APPENDIX 9-A REVISED

OPRHP Correspondence

Project: Somersset Solar Project (140-200 MW/? acres)

PR#: 21PR00981

3 WEATHER HEAD SIDE ELEVATION - TRACKERS
SCALE: NTS

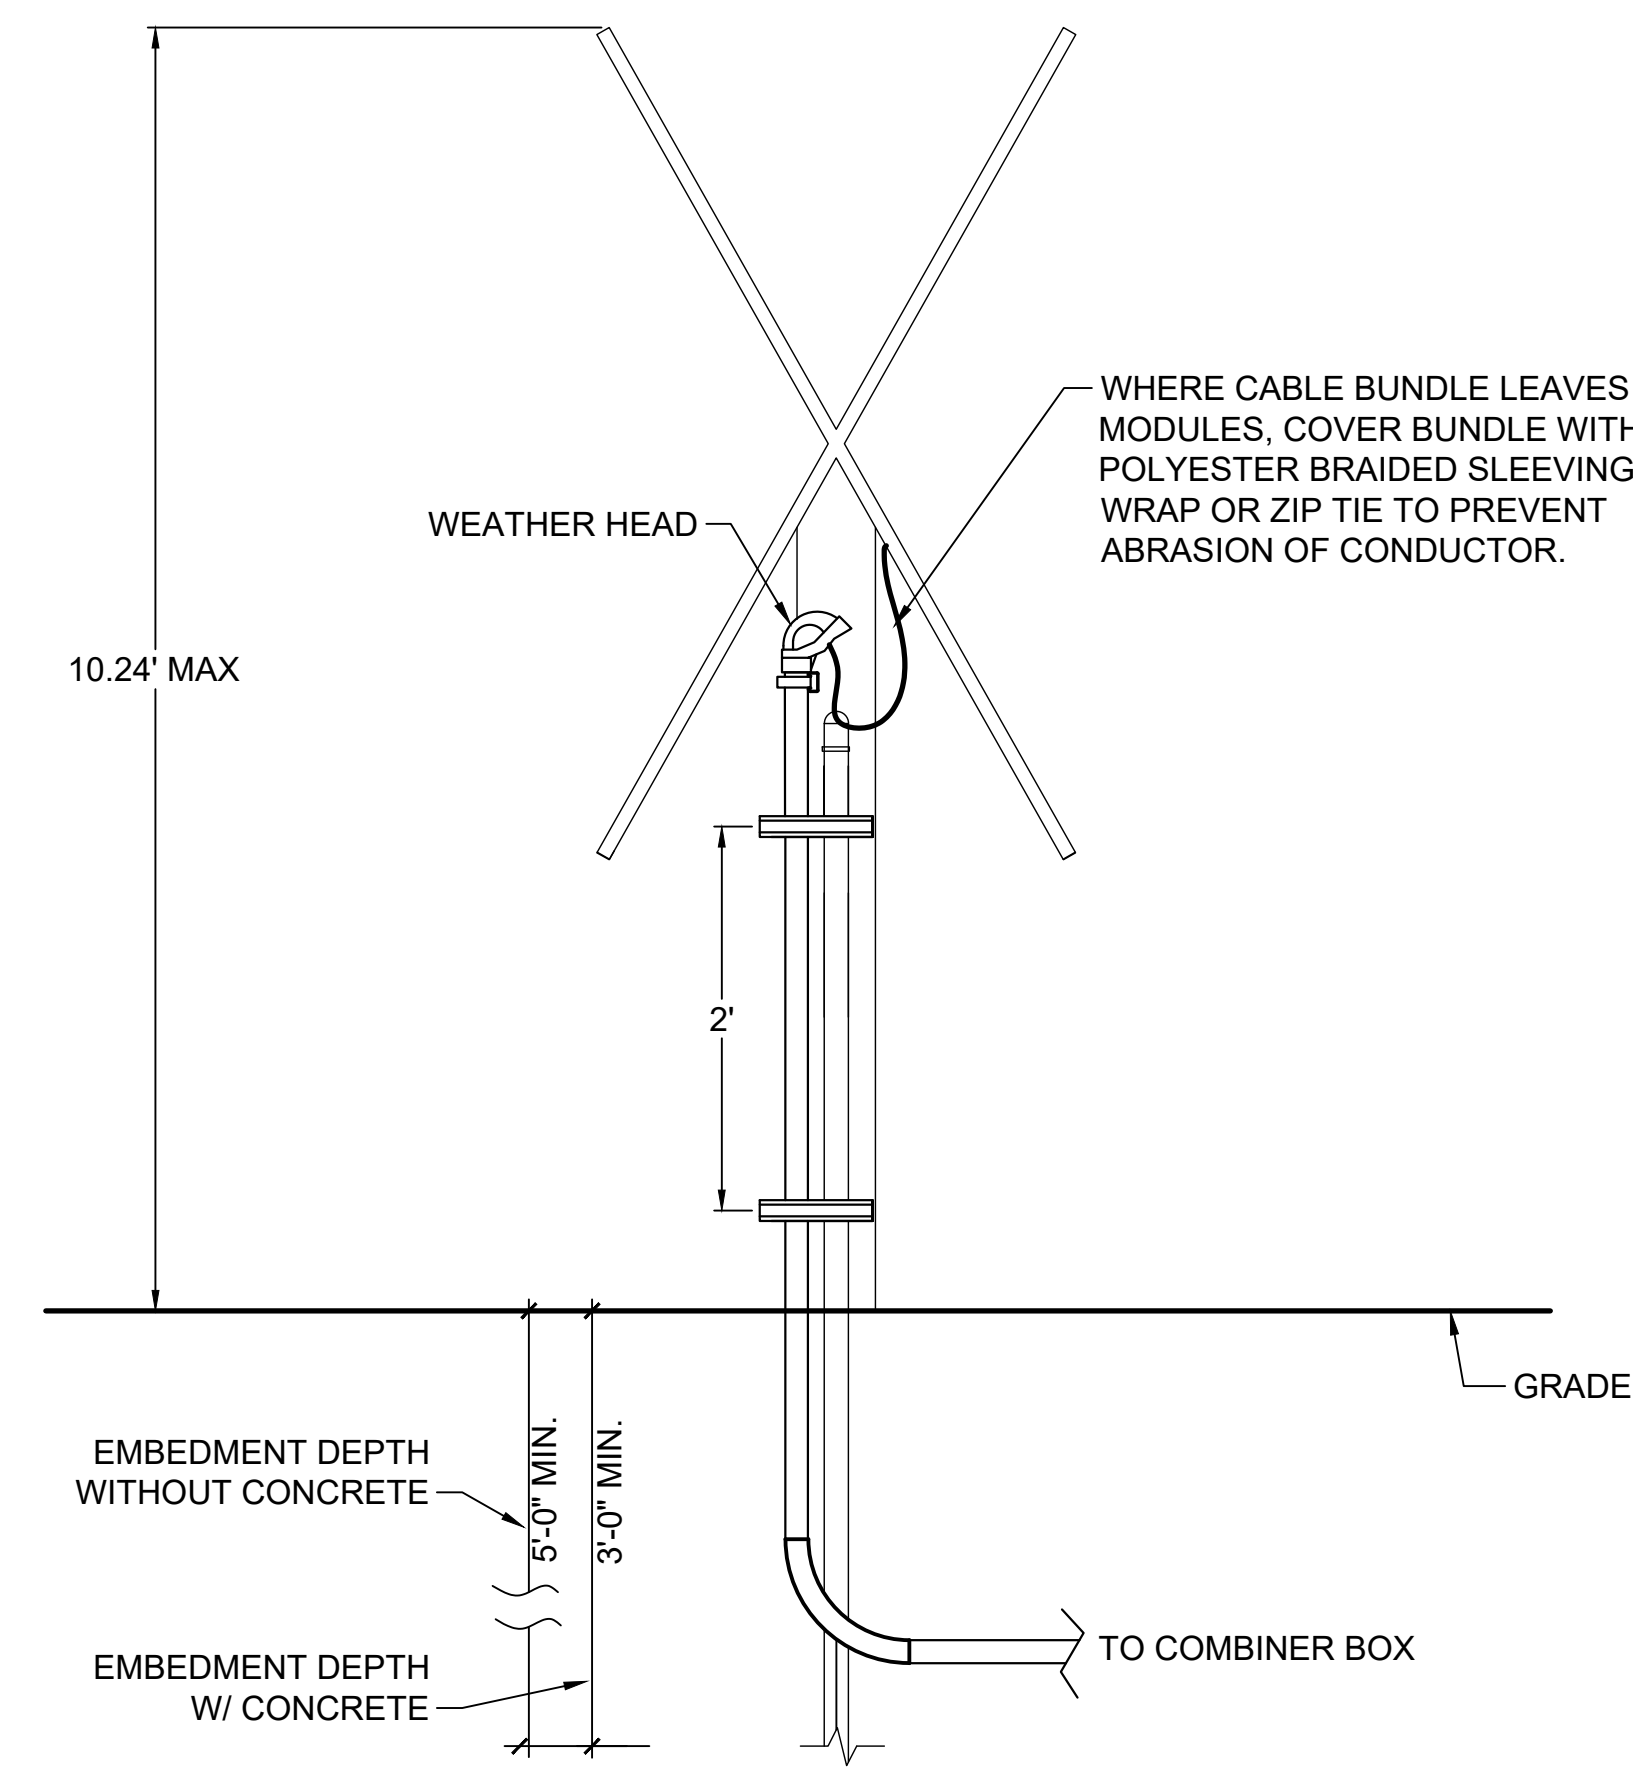
1. Detailed site plans showing solar panels, access roads, and other features, as well as any existing or proposed vegetative or topographic buffers, in the immediate vicinity of the Smith Residence and Babcock House. (It is useful for these plans to be superimposed with satellite or orthographic images.) Please also include, elevation drawings of the solar panels indicating maximum panel height and direction of rotation.

Response: The requested site plans (superimposed over aerial imagery) and elevation drawings are included in Attachment A, and include a site plan overview (PV-C.02.00), site plans for the Facility areas in the vicinity of Smith Residence (PV-C.02.01) and Babcock House (PV-C.02.02), and Conduit Management Standards (1 of 3 and 2 of 3) (PV-E.05.11 and PV-E.05.12). Both fixed tilt and single-axis panels are proposed, with fixed tilt panels having a maximum height of 7.14 feet from grade, and single-axis panels having a maximum height of 10.24 feet (maximum) from grade. The single-axis panels will be
